FOR CONTINUATION OF SCHEMATIC SEE
 (F.P. 7884 - Contn)
 DCP 1430, REV 0
 DCP CHANGE NOTE:
 DRAWING TO BE
 ADDED AT DCP CLOSURE
 DCP 1430, REV 0

DCP PACKAGE INDEX
 ITEM NO. 6.2.11

4160V AND 480V SYSTEM CONTROL AND PROTECTION			
JOB NO.	DRAWING NO.	SH.	REV.
7884	BECH-E104 (21B)	0	0

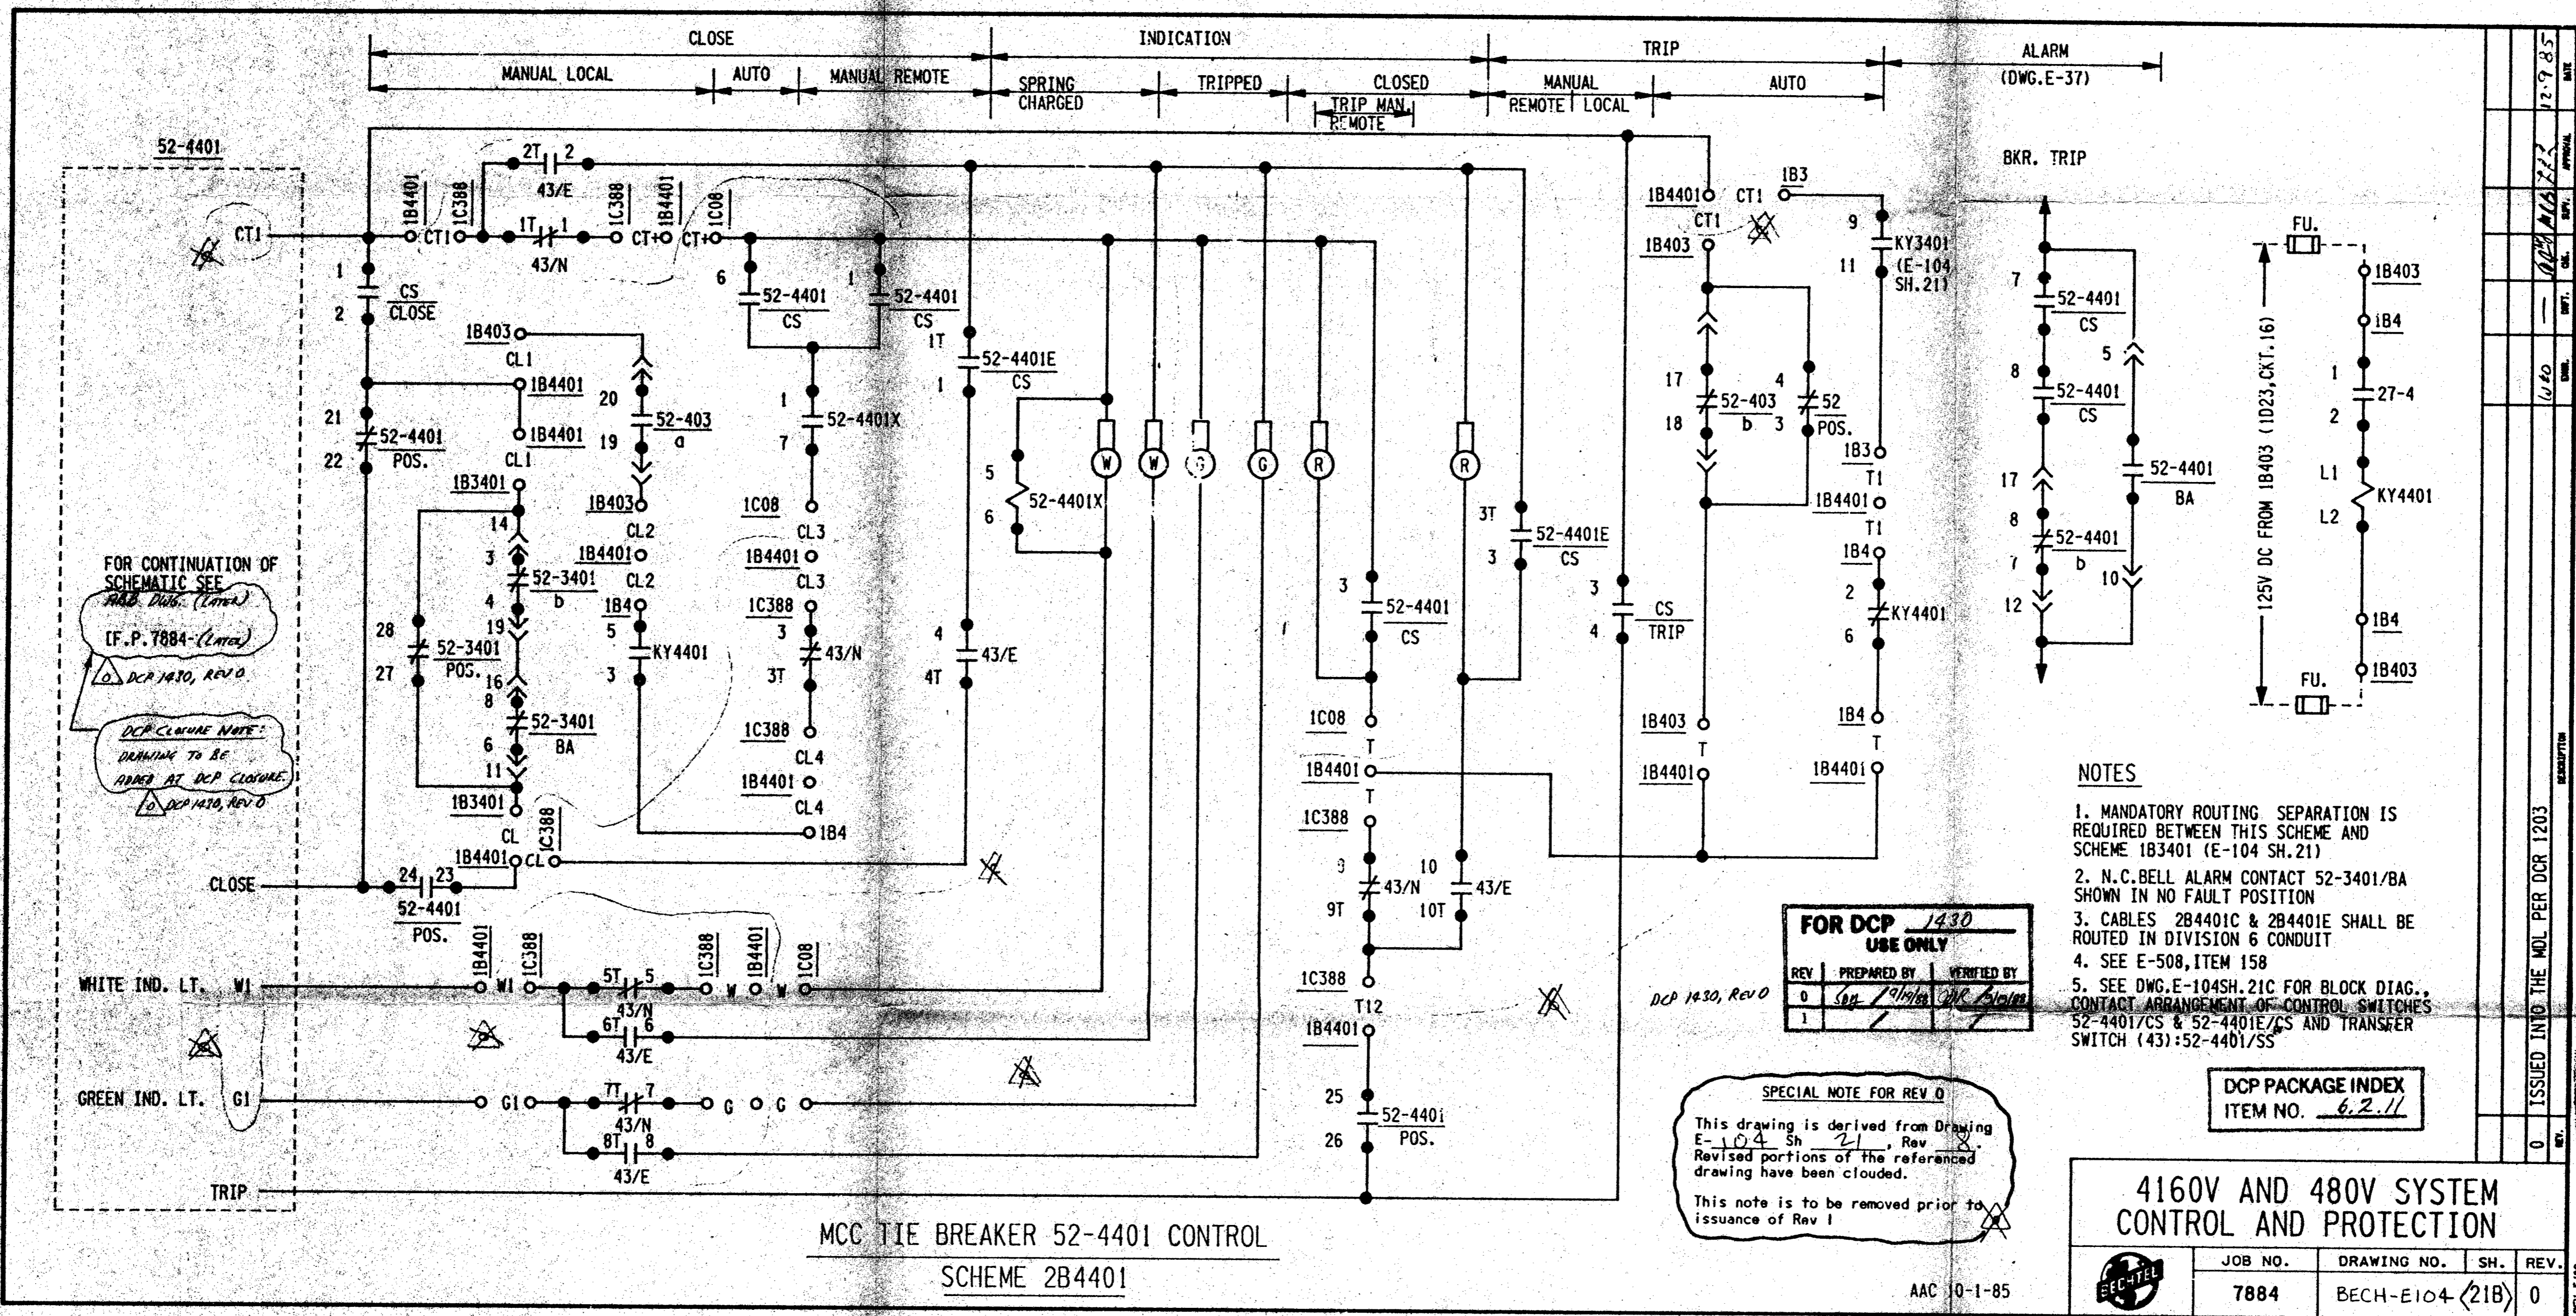
SPECIAL NOTE FOR REV 0
 This drawing is derived from Drawing E-104 Sh. 21, Rev 0. Revised portions of the referenced drawing have been clouded.
 This note is to be removed prior to issuance of Rev 1
